December 22, 2015

Public Works and Government Services Canada
201-1800 11th Avenue, Broad Street Crossing
Regina, Saskatchewan

Re: Food Services Building – Investigation of Saturated Crawlspace

SOIL CONDITION AT AREA A

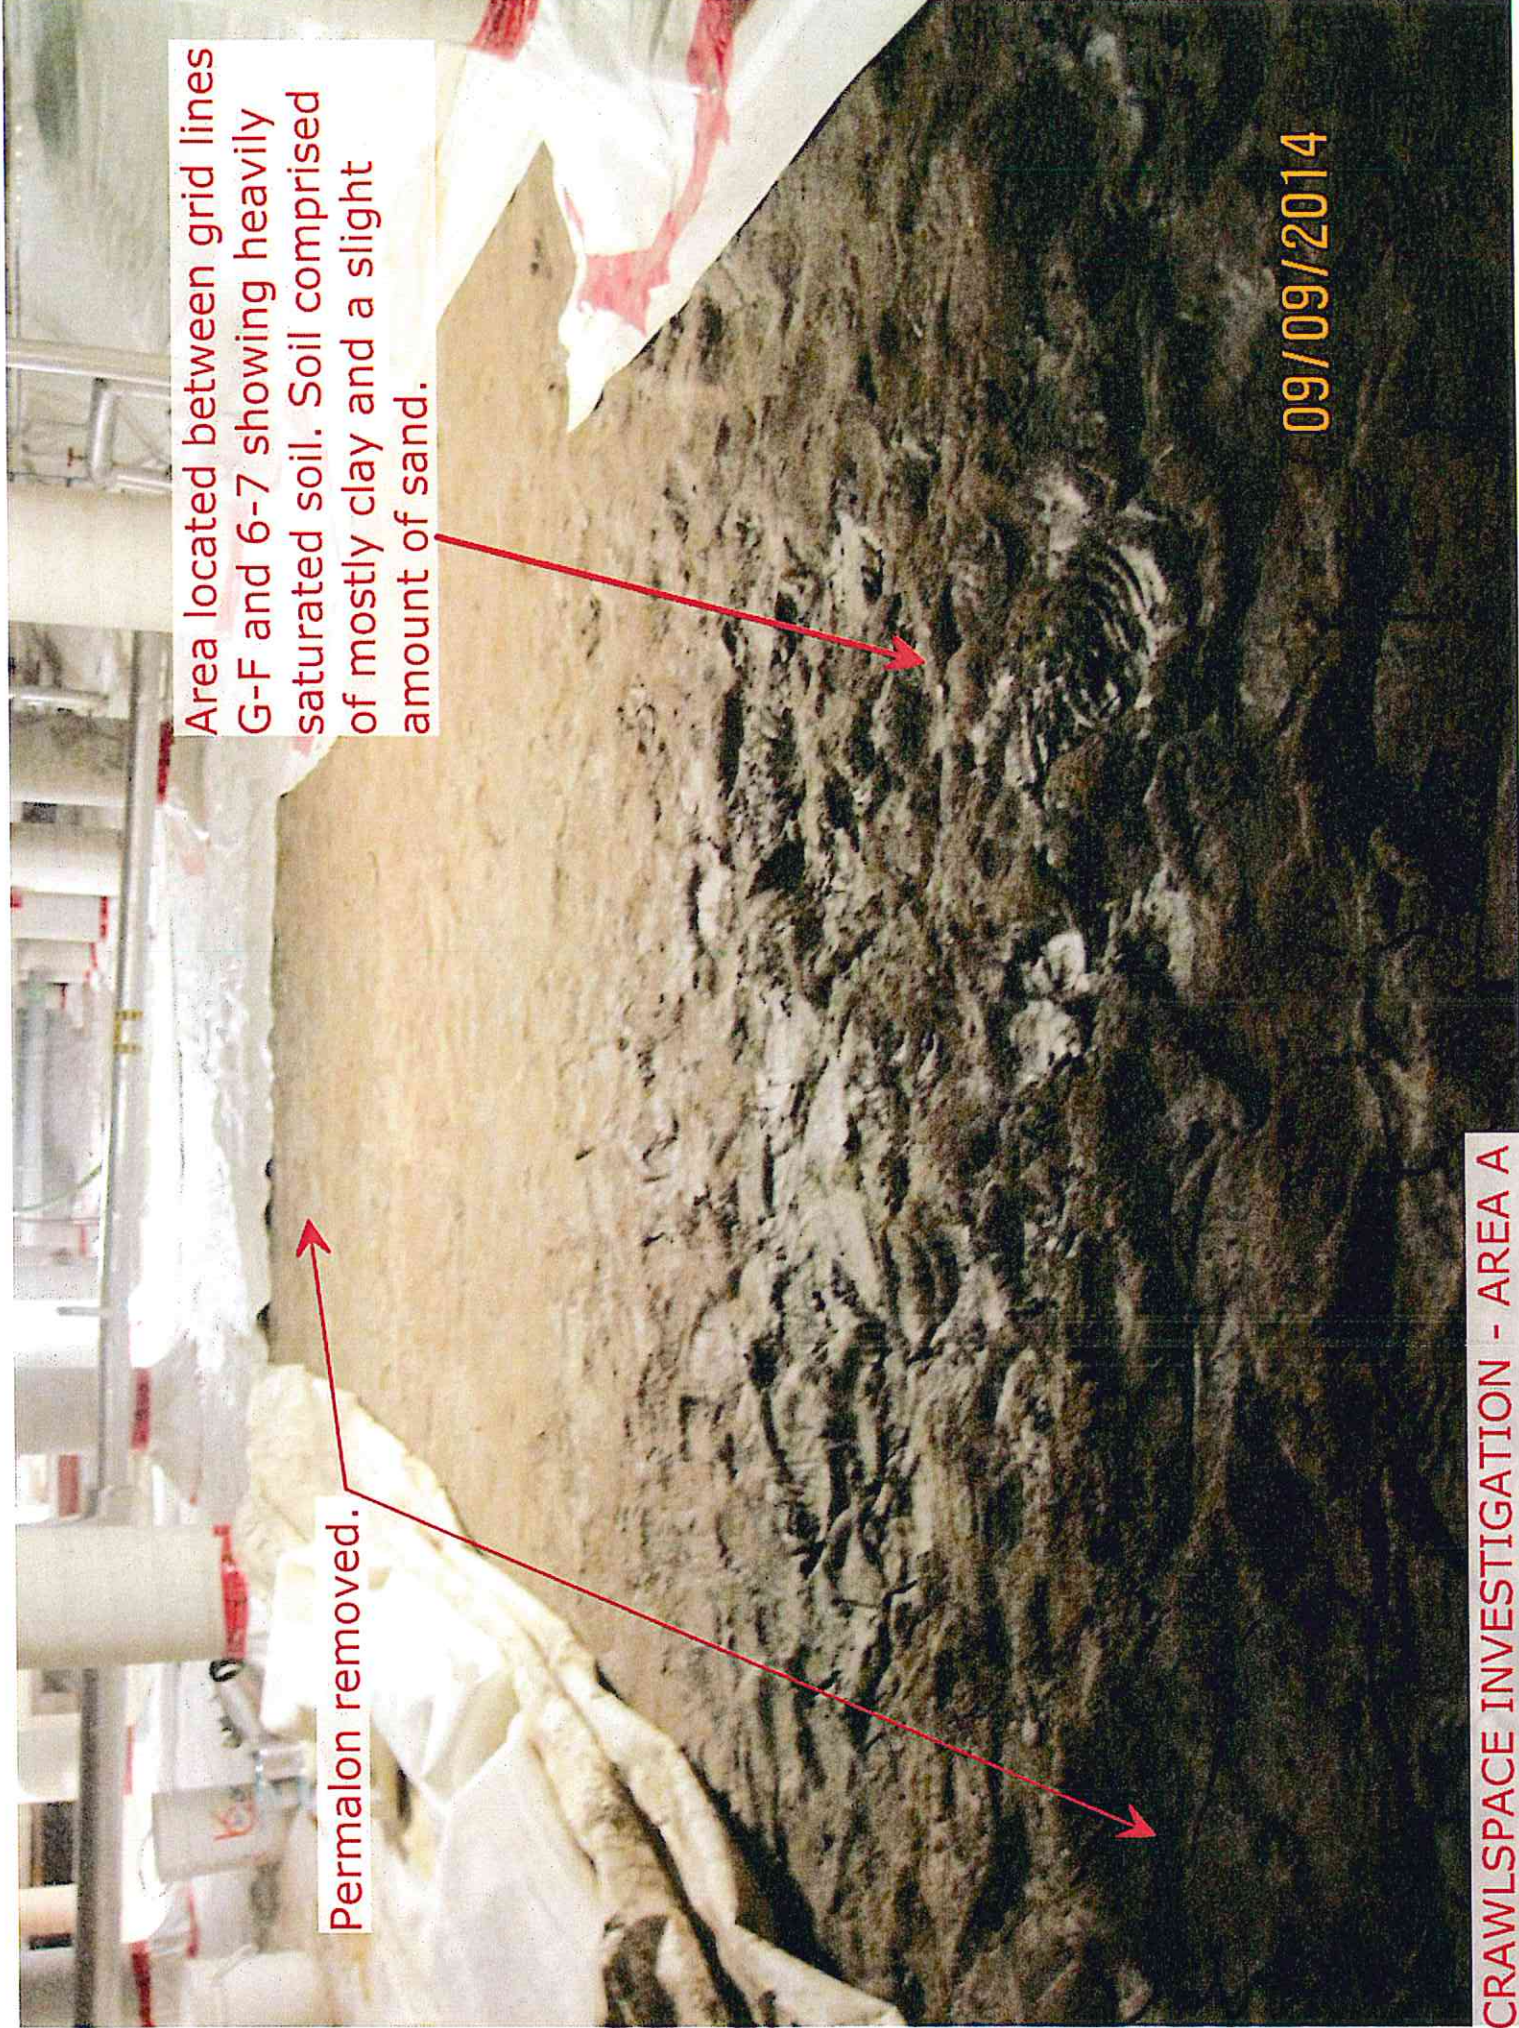
Excessive water saturation in soil.

CRAWLSPACE INVESTIGATION - AREA A

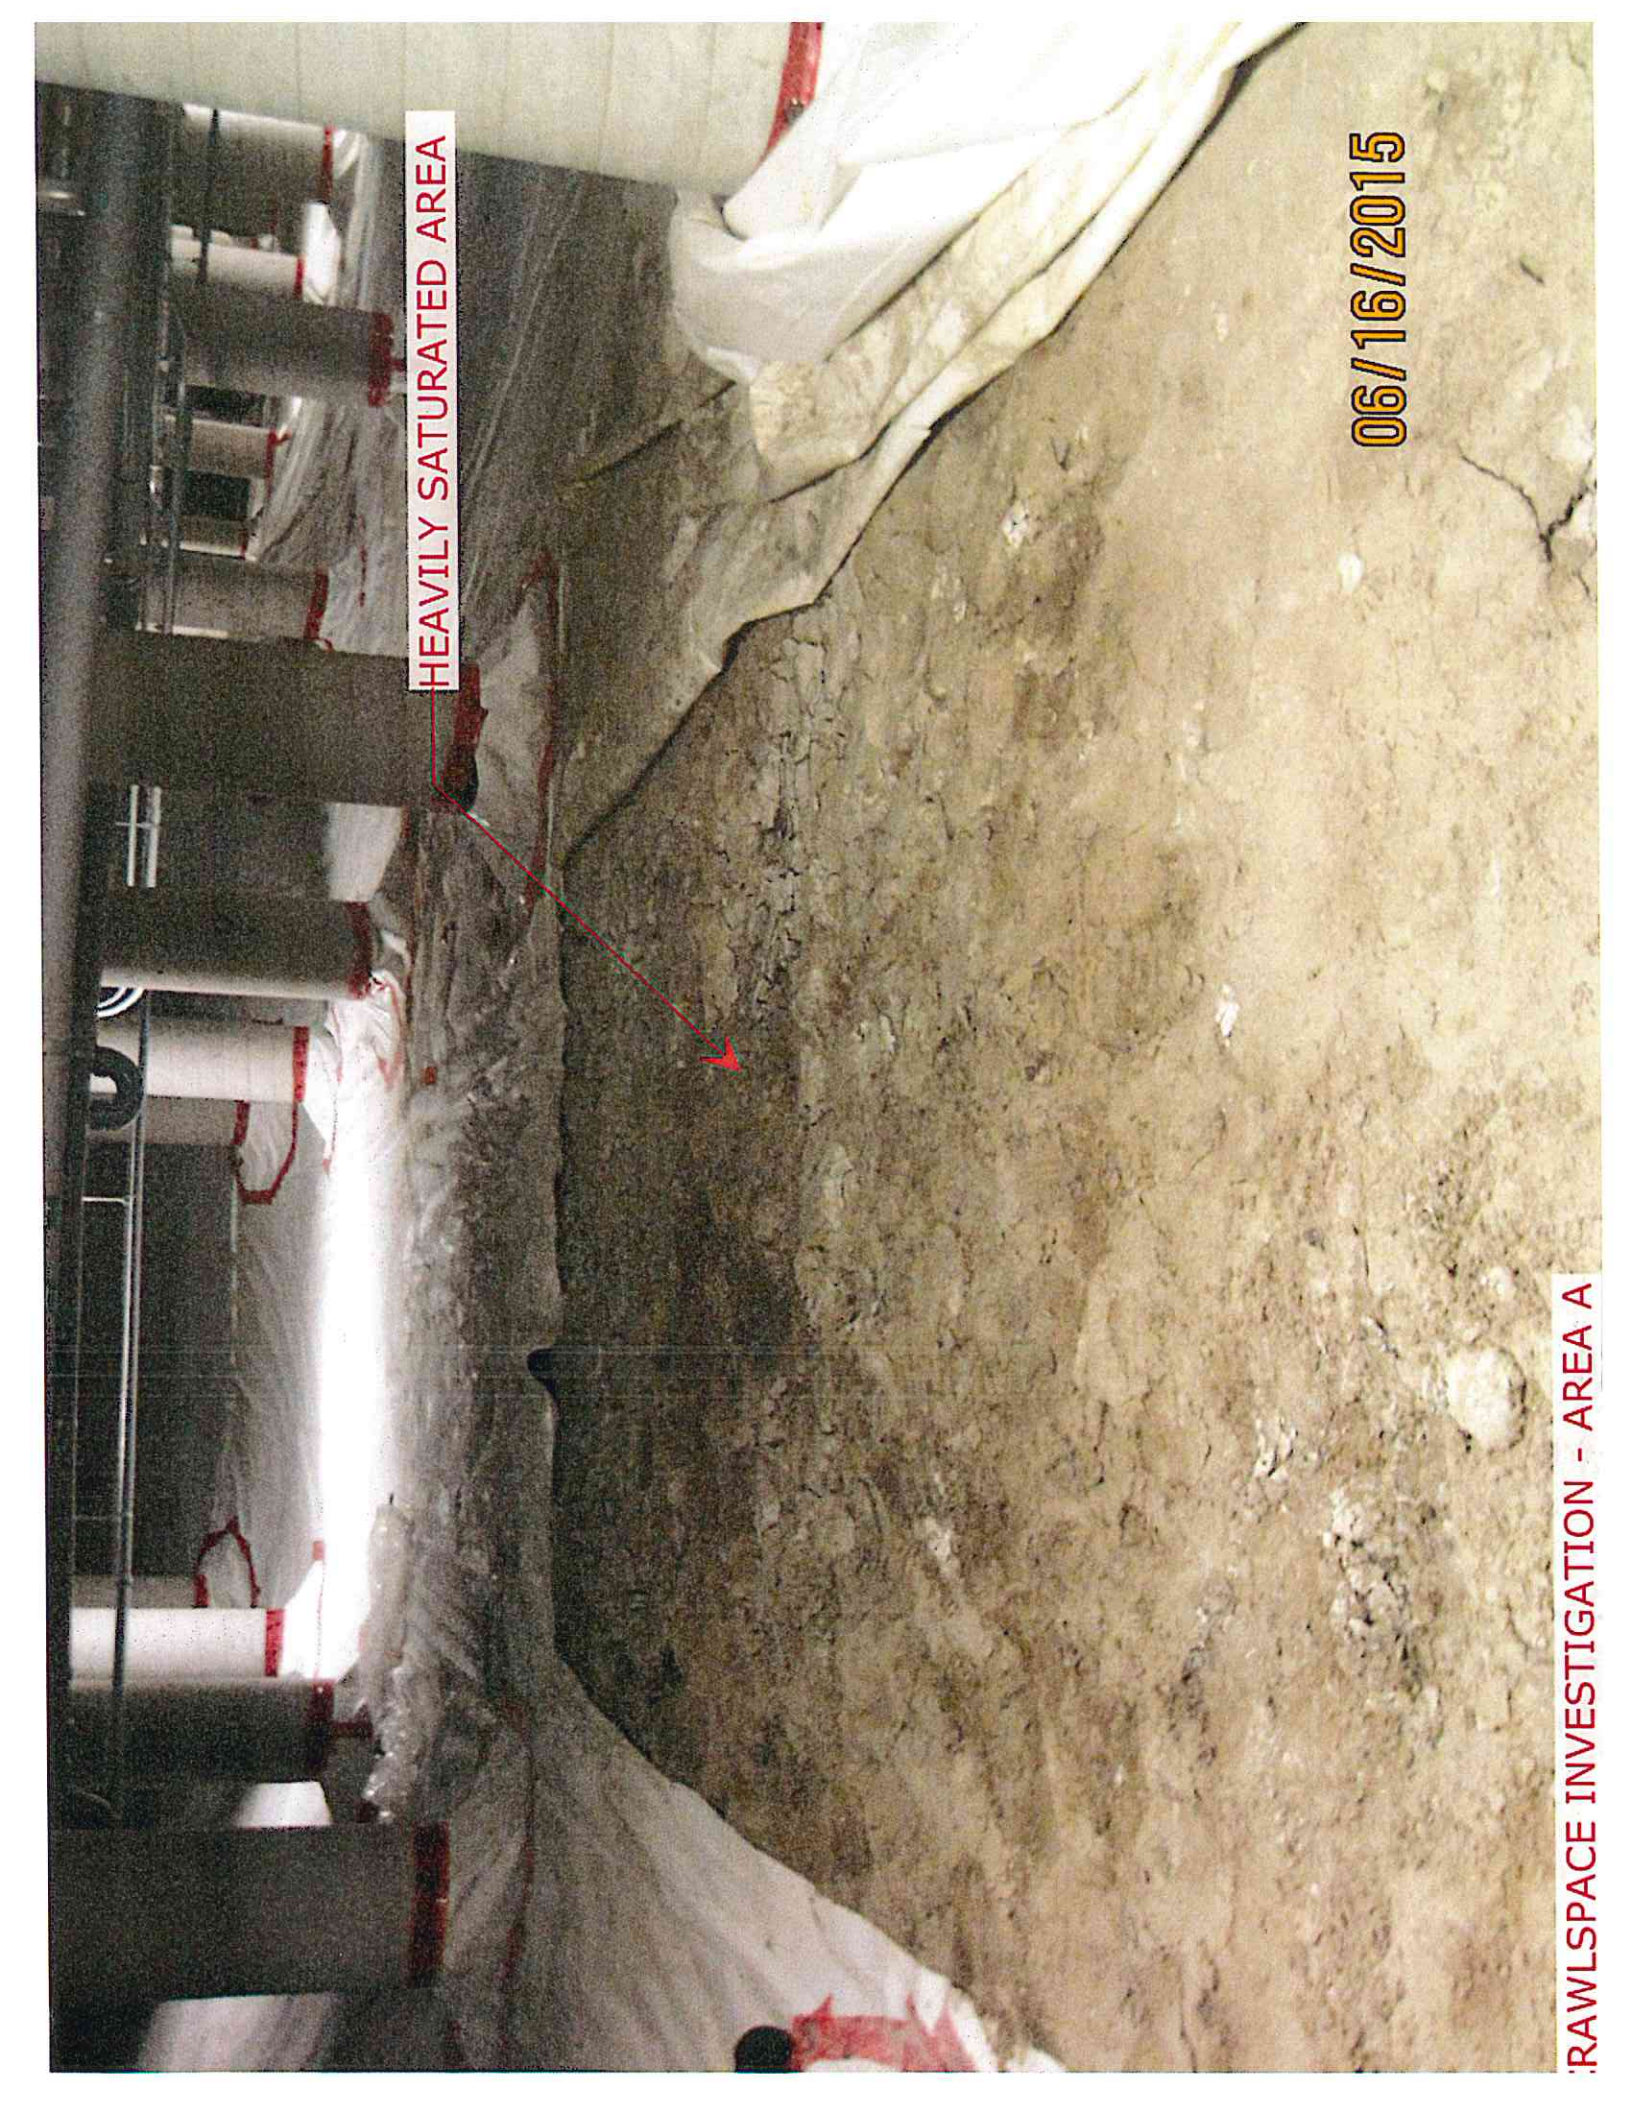
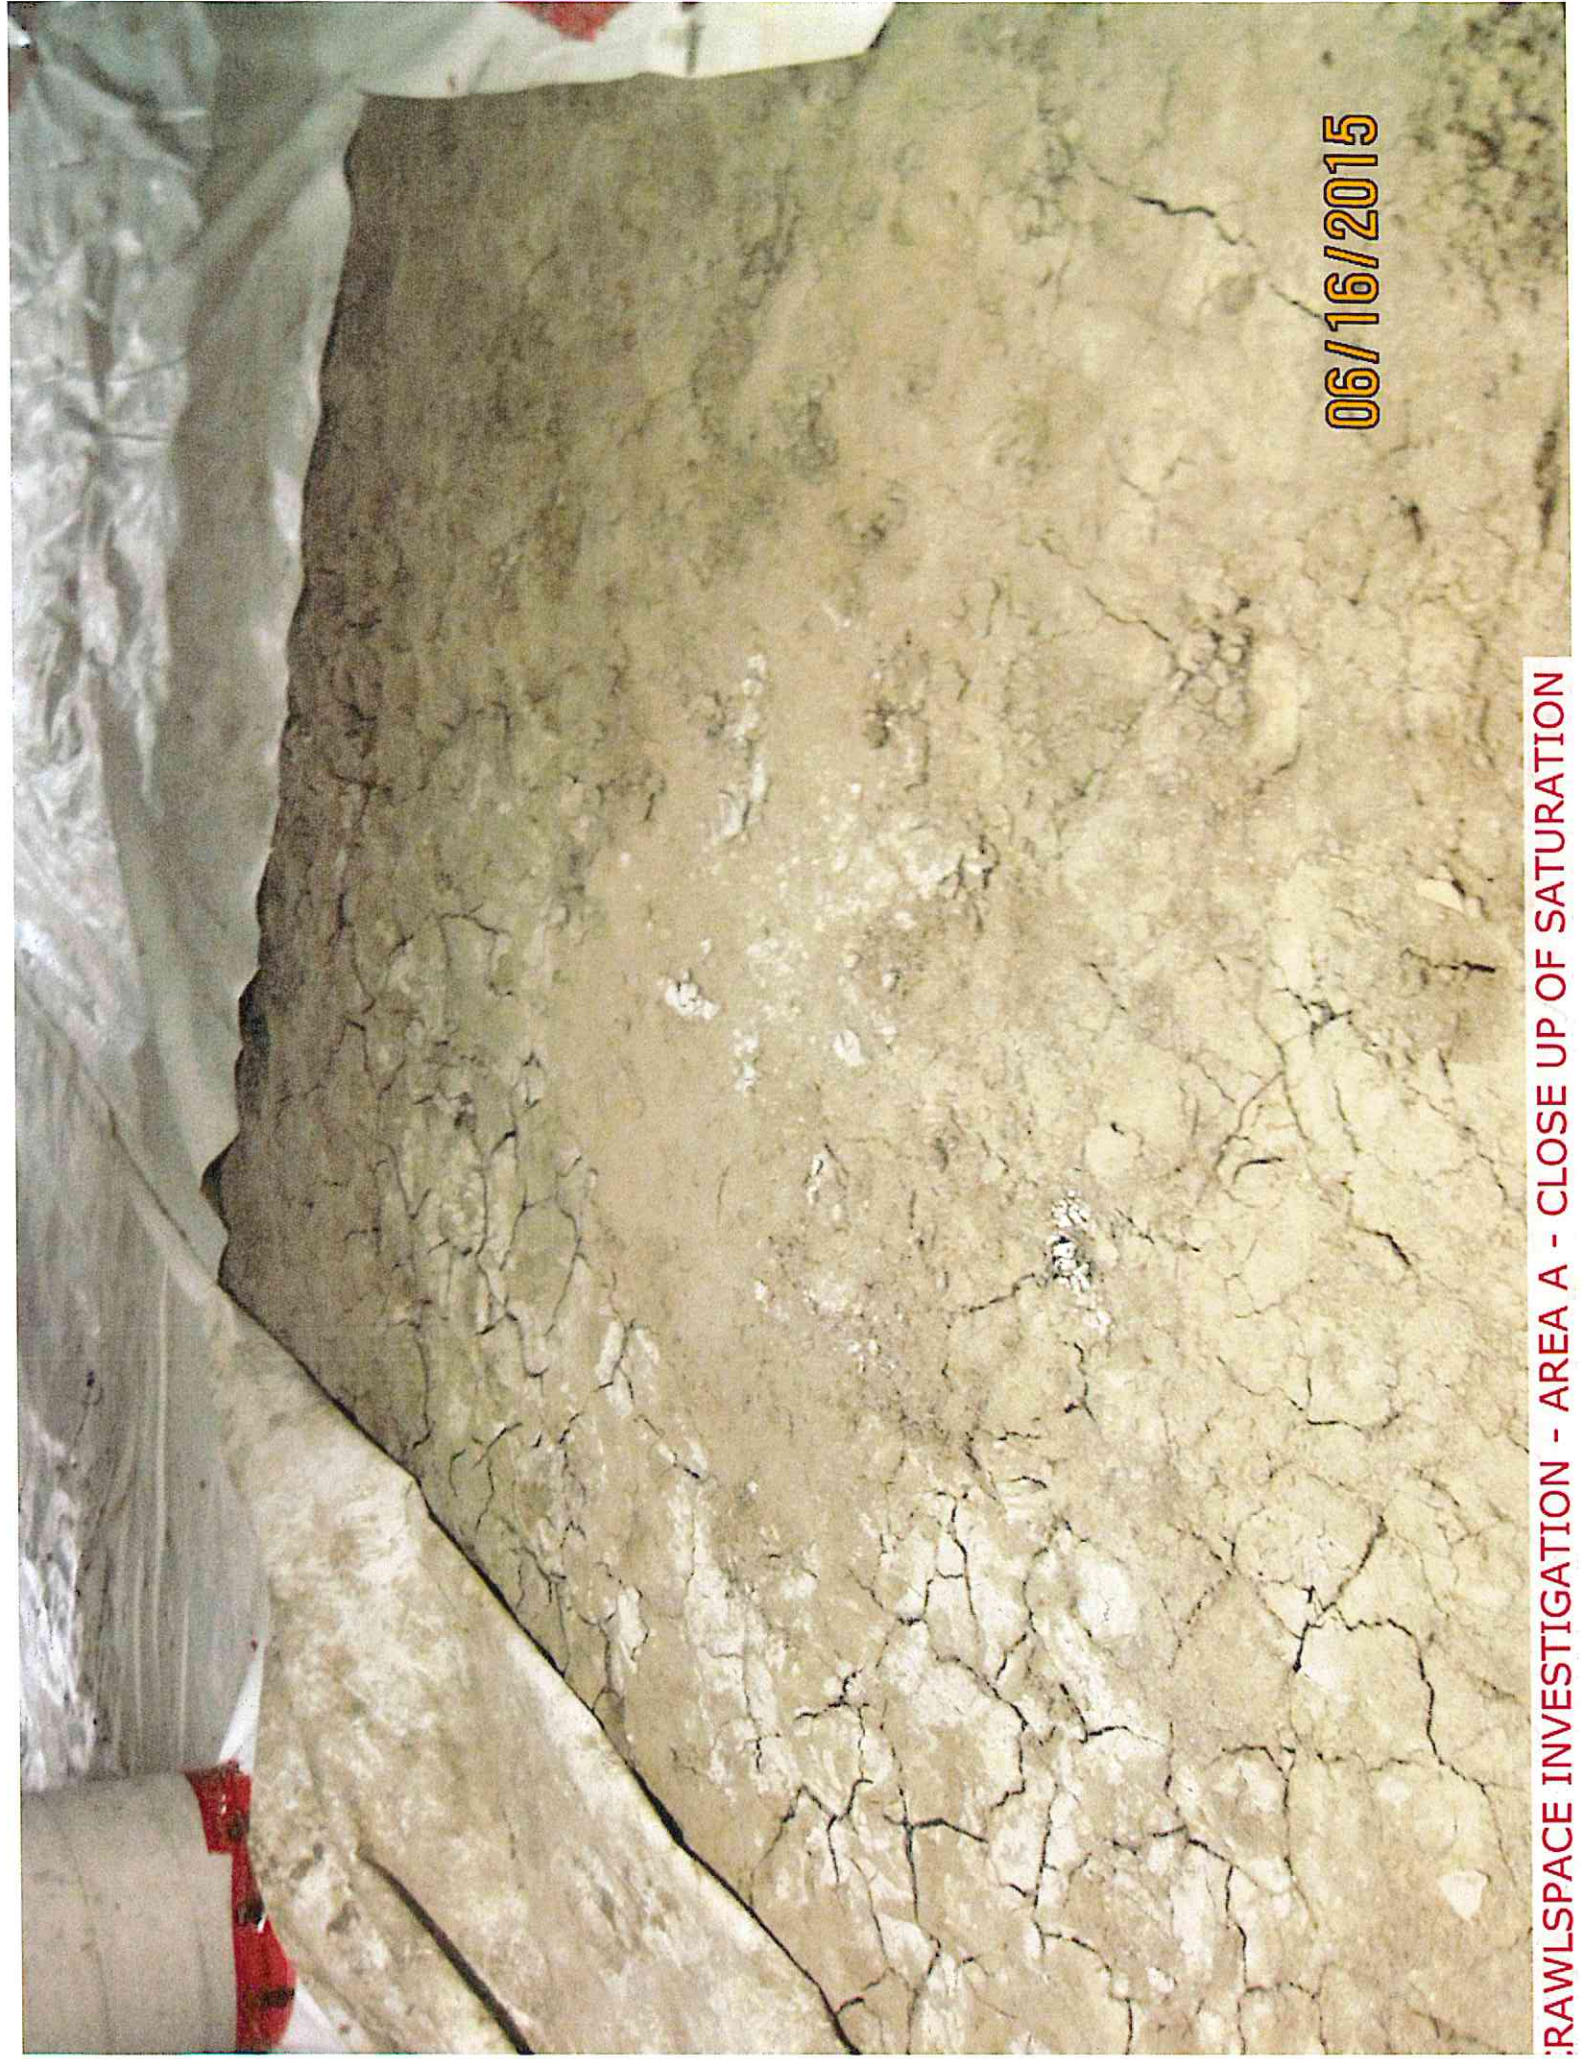
Area located between grid lines G-F and 6-7 showing heavily saturated soil. Soil comprised of mostly clay and a slight amount of sand.

Permalon removed.

HEAVILY SATURATED AREA
